Analysis of Rpeak for 200G/L AUI-C2M

Related Comment: 412

Xingxing Jiang, Chengcheng Wu, Guangcan Mi

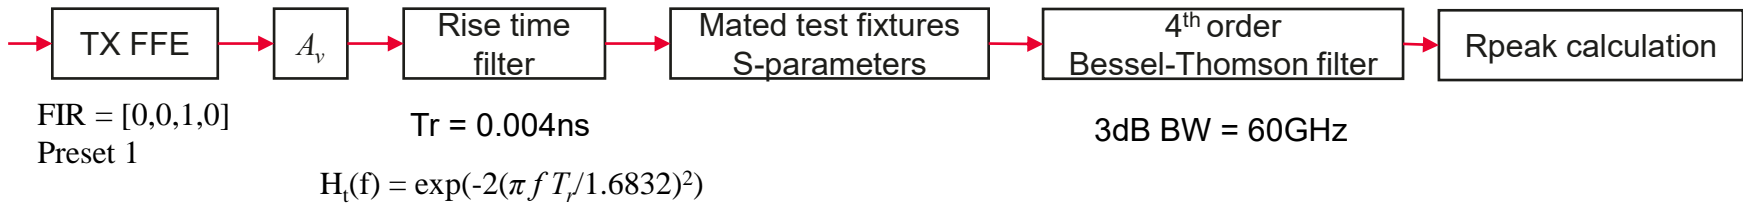
- Rpeak is introduced to the module output electrical specification of 212G/L AUI-C2M, examined at TP4. The lower bound limit is currently set to 0.567, which seems a placeholder.
- We used the MTF channel provided to 802.3dj to calculate Rpeak as a starting point.

Linear fit pulse peak ratio, R_{peak} (min)	176D.8.4	0.567	—
---	----------	-------	---

MTF IL_{dd} used in the simulation

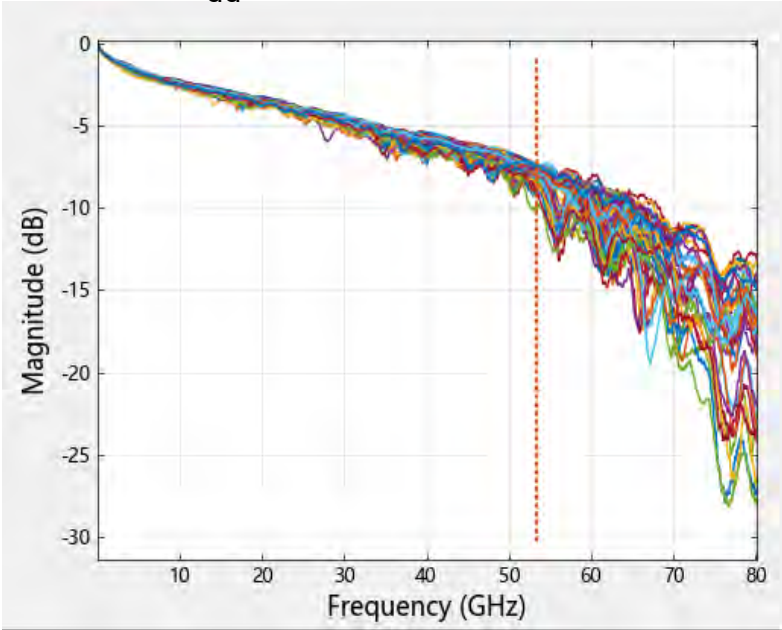
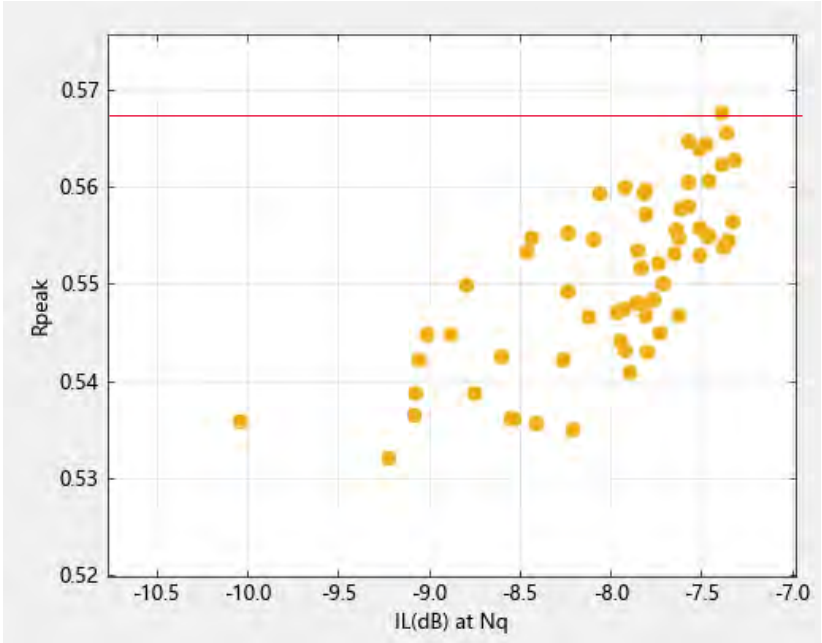
Calculated Rpeak

In mellitz_3dj_03_2505

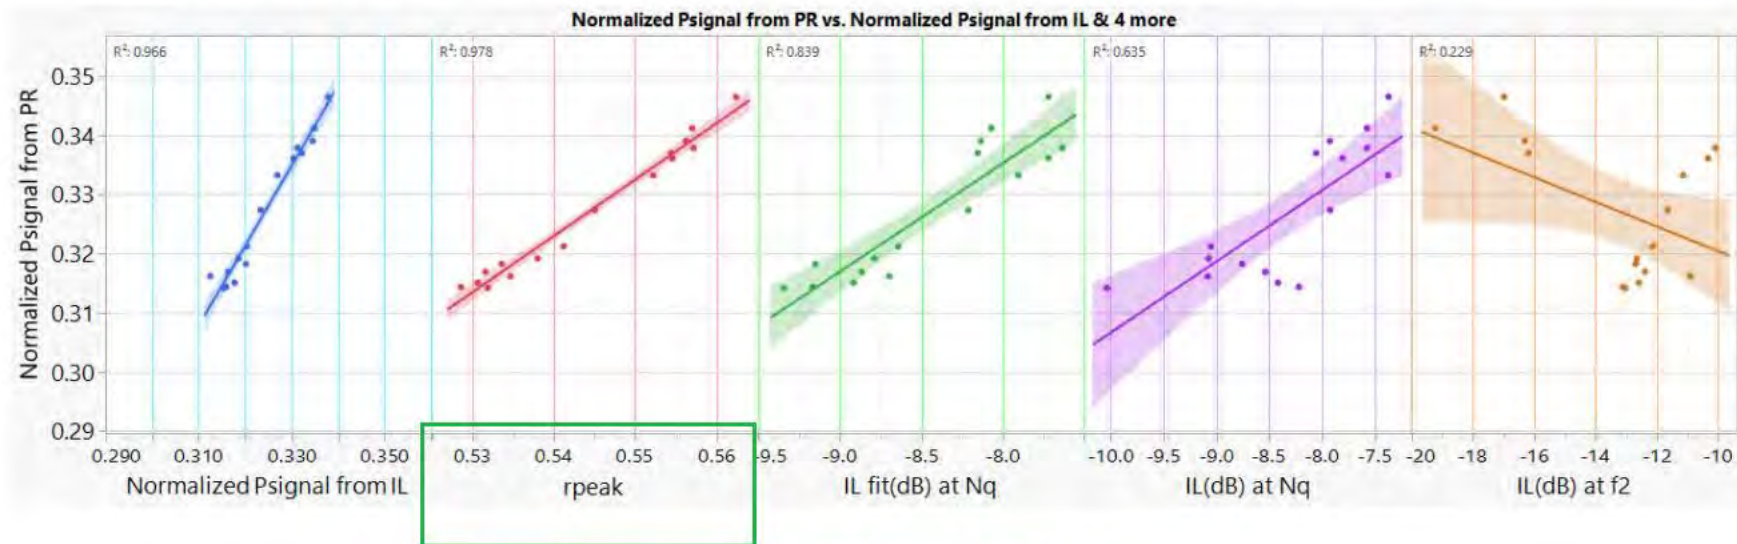
- The contribution was not about Rpeak, but the Rpeak range considered for the analysis was 0.5~0.57
- The range is below the current min. Rpeak requirement.

Is 0.5 good enough?

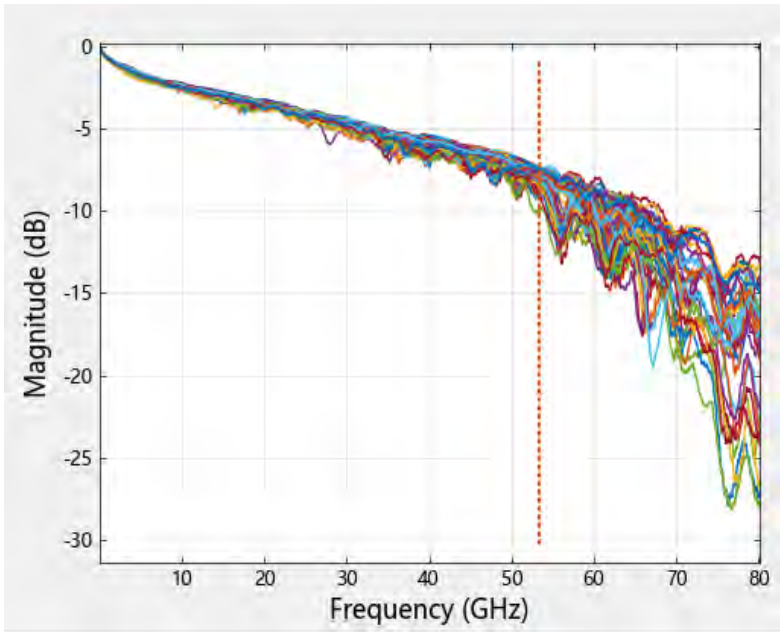
- Probably not.
- Some margin is needed for implementation w/ higher losses, and manufacturing variations.

Minimum IL of these data set <10dB

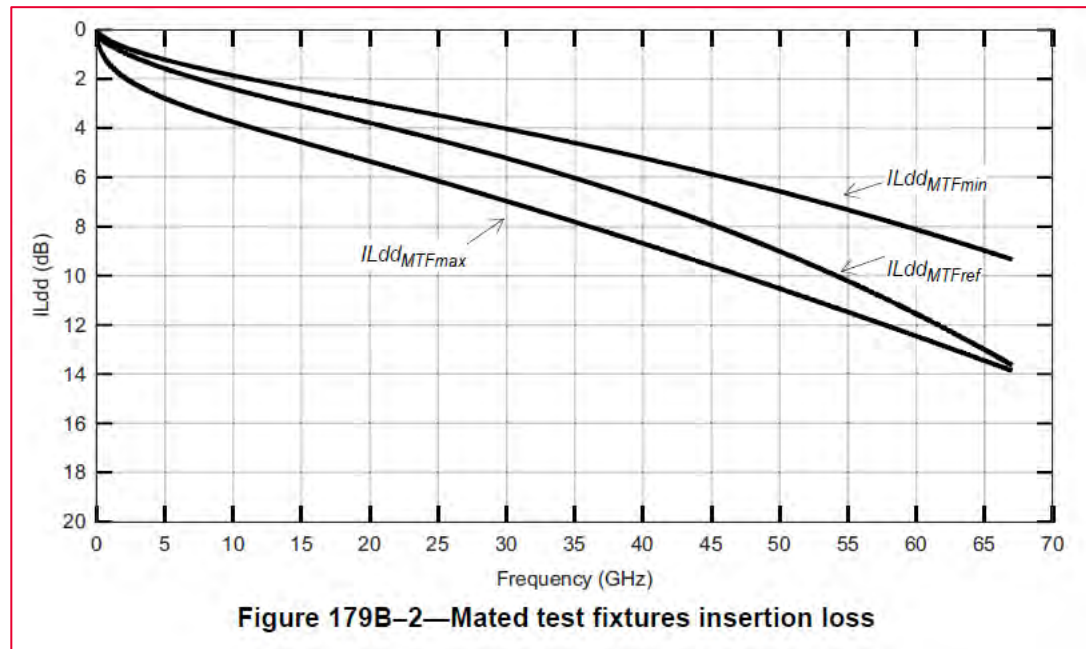
Minimum IL allowed ~11dB
